CM CLARIFICATION #013
PROJECT: CNE Tahlequah Casino

July 25, 2018

Foreman Manhattan Team has added and/or revised the following CM Manual documents for review and inclusion by all contractors within their Scope Package Proposal:

1 ENLARGED REFLECTED CEILING PLAN
3/16" = 1'-0"

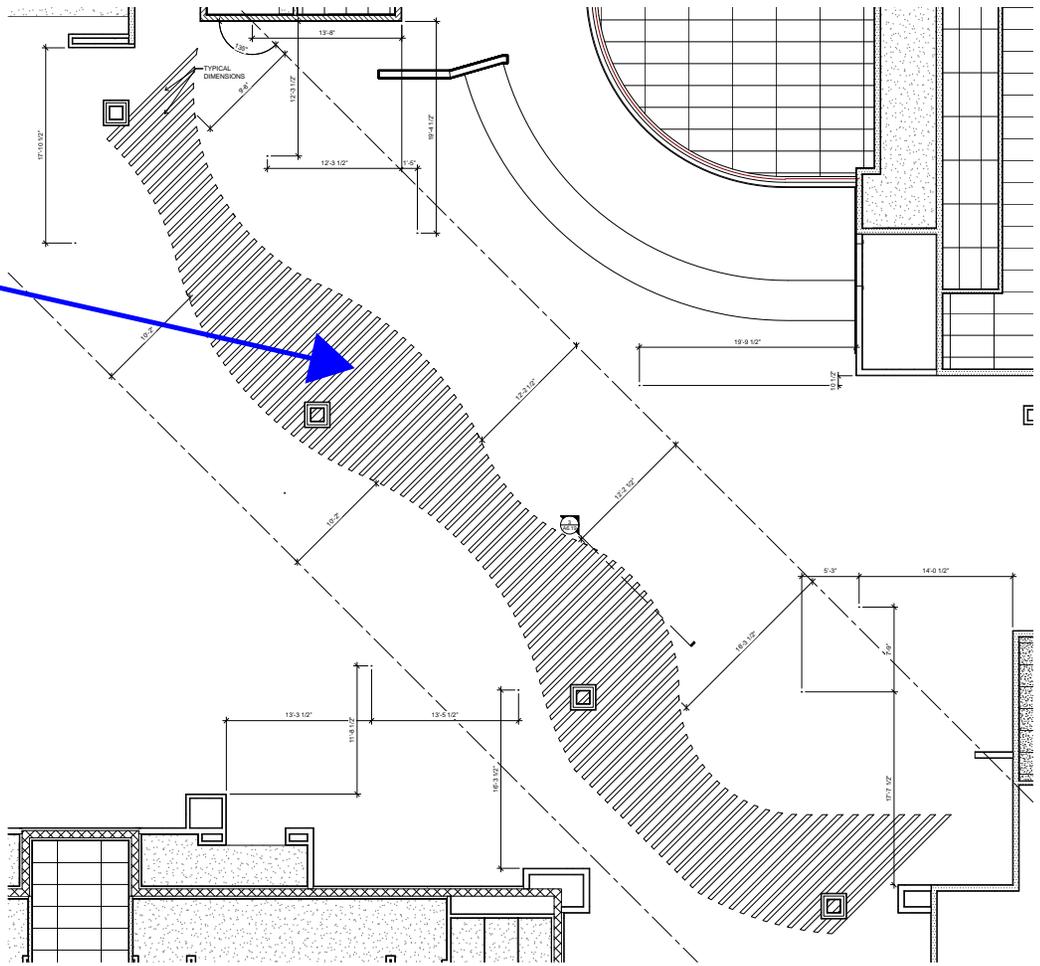
Provide linear ceiling elements identified as Theming Millwork Ceiling Alternate 1 on North end of casino.

Provide linear ceiling elements identified as Theming Millwork Ceiling Alternate 2 on South end of casino.

Provide linear ceiling elements identified as Theming Millwork Ceiling Alternate 3 on South end of casino.
